AGENDA
PLANNING AND ZONING COMMISSION MEETING
CITY OF CREVE COEUR, MISSOURI
MONDAY, MAY 2, 2016
6:30 PM

**APPLICATION TO PLANNING AND ZONING COMMISSION
#16-014 FOR AN AMENDMENT TO THE CONDITIONAL USE
PERMIT FOR GRANITE CITY FOOD & BREWERY RESTAURANT AT
11411 OLIVE BOULEVARD**

**APPLICATION TO PLANNING AND ZONING COMMISSION
#16-015 A MINOR SITE DEVELOPMENT PLAN FOR 10721
KINGSBRIDGE ESTATES DRIVE FOR A FENCE WITHIN THE FRONT
YARD SETBACK.**

APPLICATION TO PLANNING AND ZONING COMMISSION #16-013 APPROVAL OF A REVISED SITE CONCEPT PLAN FOR MISSOURI BAPTIST UNIVERSITY AND SITE DEVELOPMENT PLAN FOR NEW PARKING FACILITIES THROUGHOUT THE CAMPUS

Exterior Refresh

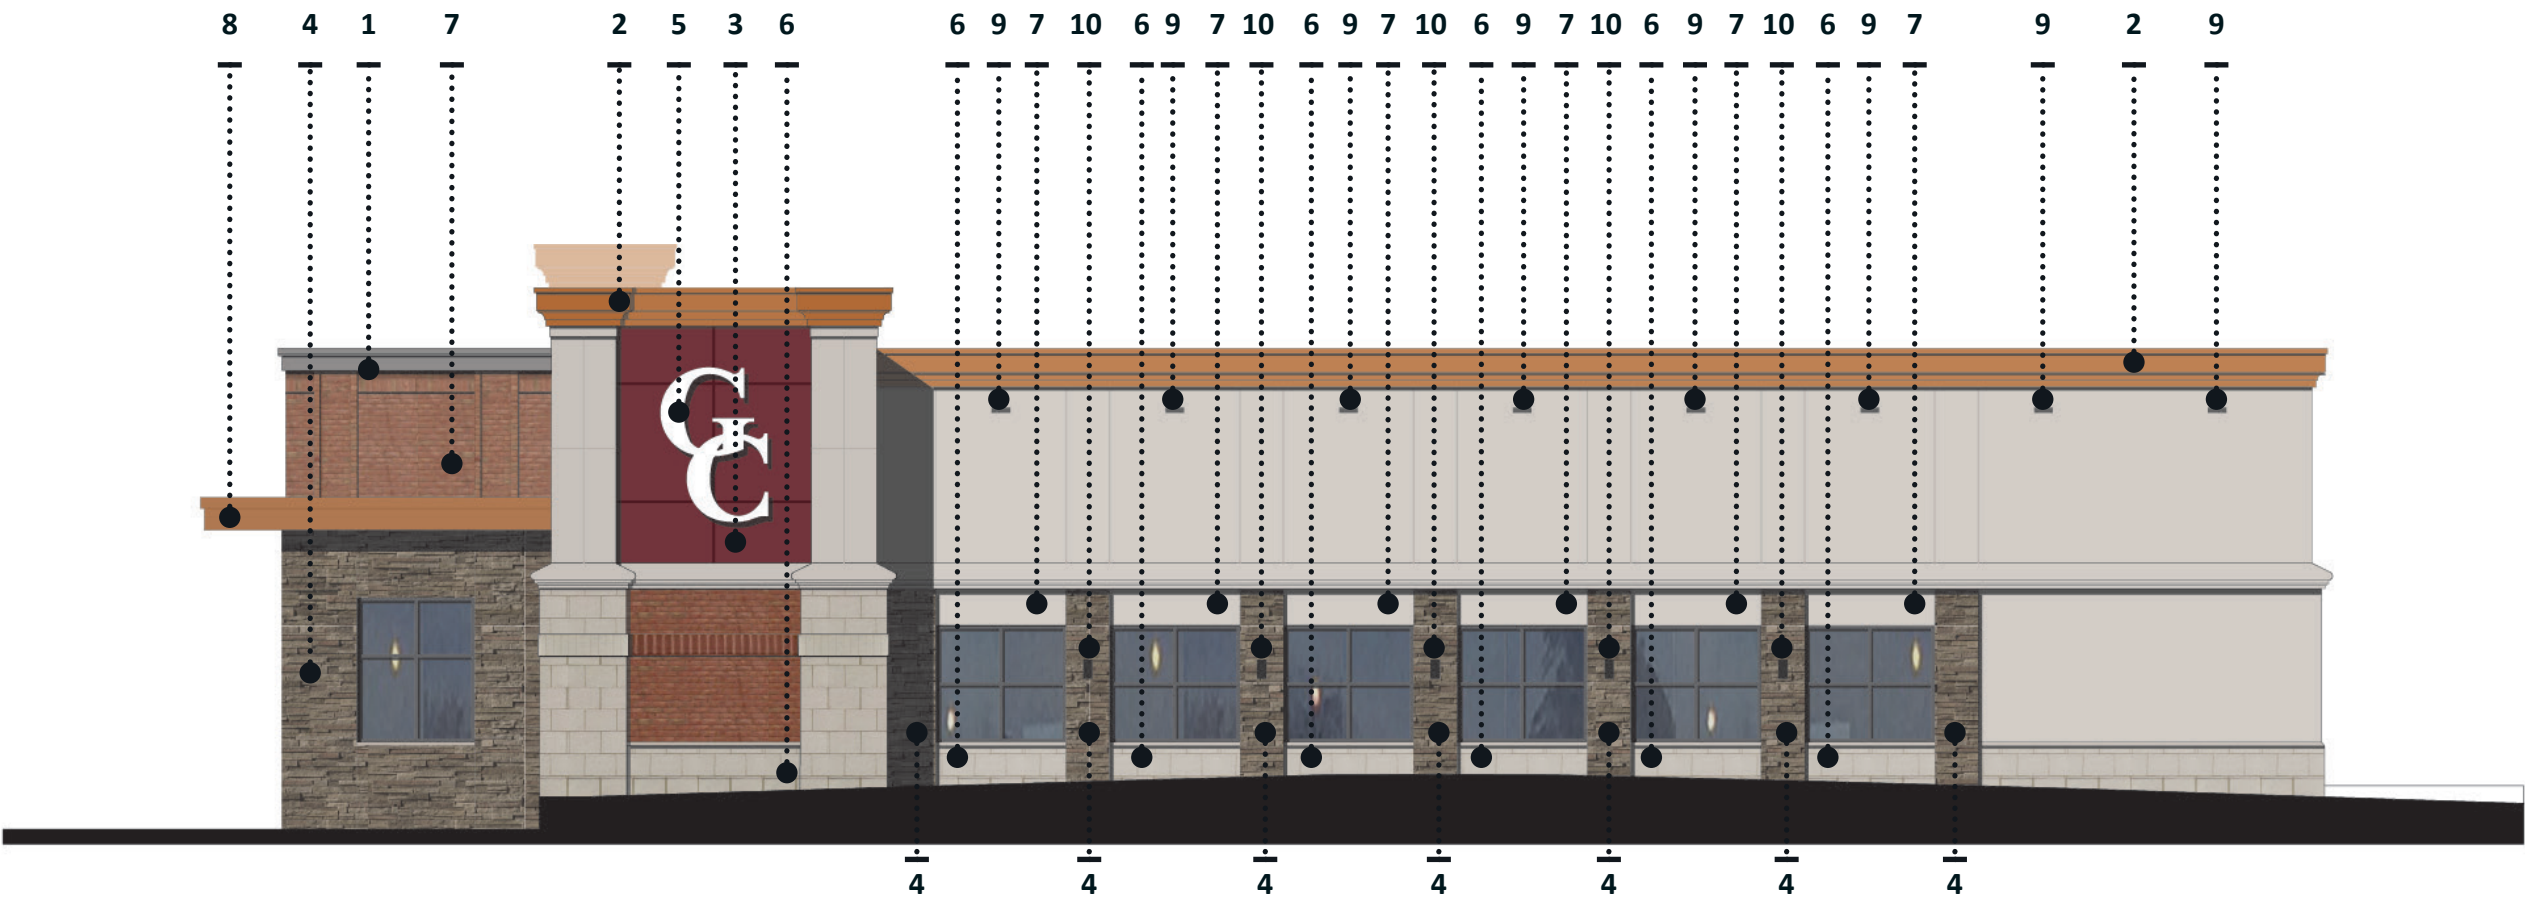
The interior remodel of the space was completed last year without the patio or expansion of the bar area. In an effort to update the exterior of the space, the Applicant is seeking approval of additional stacked stone, and to paint the area around the signs a dark maroon color and add new downcast lighting, per the images below:

The Applicant’s initial request was to paint the existing EIFS on the building the same red as the corporate logo, along with additional building materials. However, the final drawing shows a darker color maroon and a reduction of proposed materials, in order to address the recommendations of the Design Guidelines. Whether or not this still constitutes “signing” of the building/the tenant space is for the Commission members to determine. The addition of the stacked stone provides for a new element on the building that is not found elsewhere within the center. However, Staff finds that it provides greater interest at the pedestrian level, and updates the exterior of the space, which already has some design element and materials that are not found elsewhere in the center.

Figure 4: Close-up of the Site Development Plan for Phase I Parking

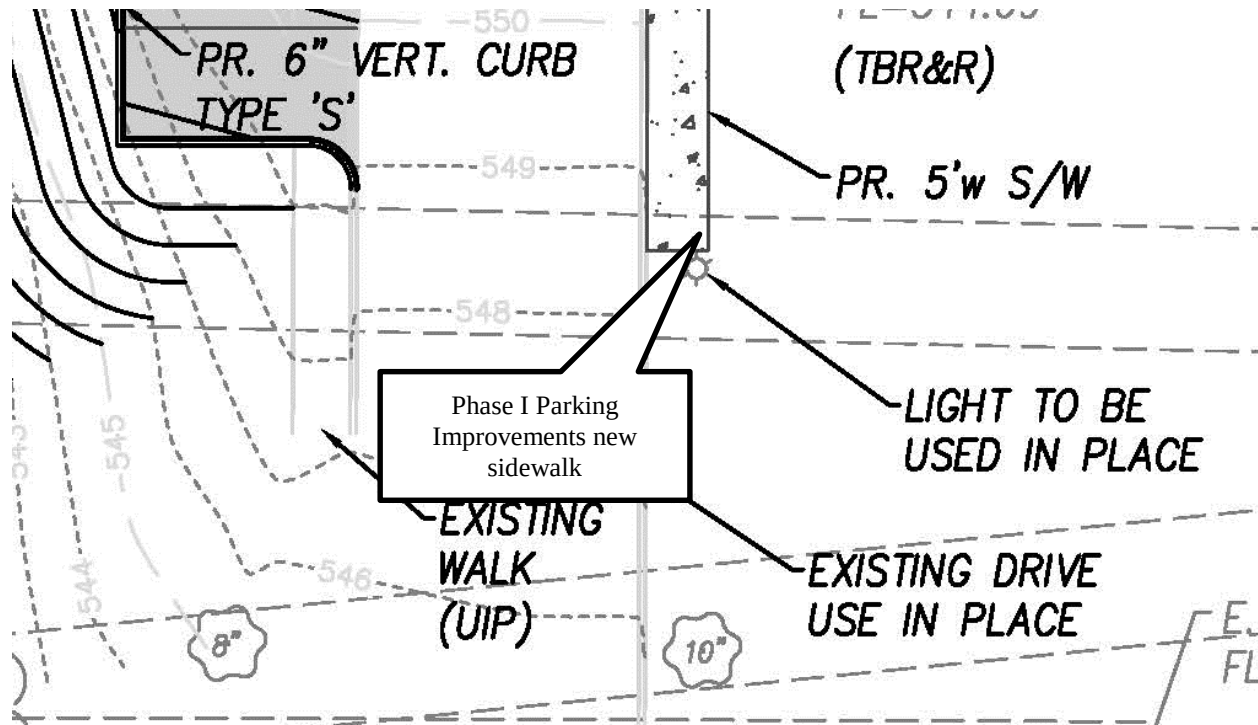
The Site Development Plan for this area does not include sufficient pedestrian connections, with the existing sidewalk ending at the new Phase I area and then moved to the east, per the image below:

A pedestrian crosswalk needs to be included, and additional connections will need to be shown for Phase II. Therefore, Staff has included a condition of approval that the site development plan shall be revised to meet with the requirements of Section 405.730 Sidewalks of the Zoning Ordinance, where a minimum width of internal sidewalks in non-residential developments shall be at least six feet or eight feet if used as a curb stop.
